**DOCKET NUMBER 50-483  
CALLAWAY PLANT UNIT 1  
UNION ELECTRIC CO.  
FACILITY OPERATING LICENSE NPF-30  
PART 21 Notification – Prime Measurement Products  
Models 763 & 763A Pressure Transmitters and  
Model 764 Differential Pressure Transmitters**

This letter completes the Part 21 Notification regarding PRIME (formerly ITT Barton) Models 763 & 763A Pressure Transmitters and Model 764 Differential Pressure Transmitters. An initial notification was completed November 18, 2005 as Event Notification Number 42151.

## **NUCLEAR INDUSTRY ADVISORY**

### **Barton Model 763, Model 763A and Model 764 Zener Diodes**

**Larger Commercial Zener Diode & Smaller Similar Glass Body JANTX Zener Diode**

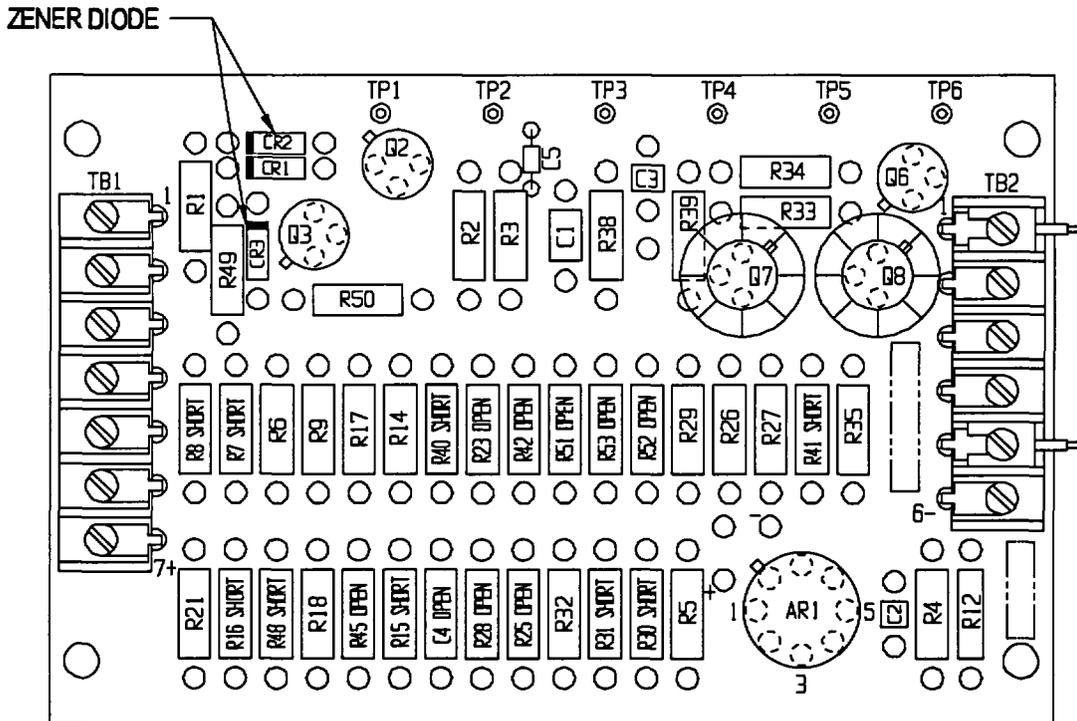
1. This notification involves 76 specific transmitters manufactured between February 10, 2004 and September 19, 2005.
2. Each transmitter contains two Zener diodes which may not comply with purchase specifications.
3. The JANTX Zener diodes are different in appearance with respect to the commercial variations. Some JANTX Zener diodes used in the recent past have bodies that are solid orange or light blue in color or clear glass. The commercial Zener diodes in question have a clear glass body. The commercial Zener diode is larger (0.095" diameter X 0.275" long) than the smaller JANTX Zener diode (0.072" diameter X .155" long).

The JANTX Zener diodes are different in appearance with respect to the commercial variations. Some JANTX Zener diodes used in the recent past have bodies that are solid orange or light blue in color or clear glass. The commercial Zener Diodes that have been used have a body that is clear glass. The attached photo compares the larger commercial Zener diode (0.095" diameter X 0.275" long) with the smaller JANTX Zener diode (0.072" diameter X .155" long) that has a glass body. The existence of the commercial Zener diode can be verified by visual inspection. Remove the transmitter electronics cover and visually observe the Zener diodes at locations CR2 and CR3 as shown on the attached drawing of the circuit board.
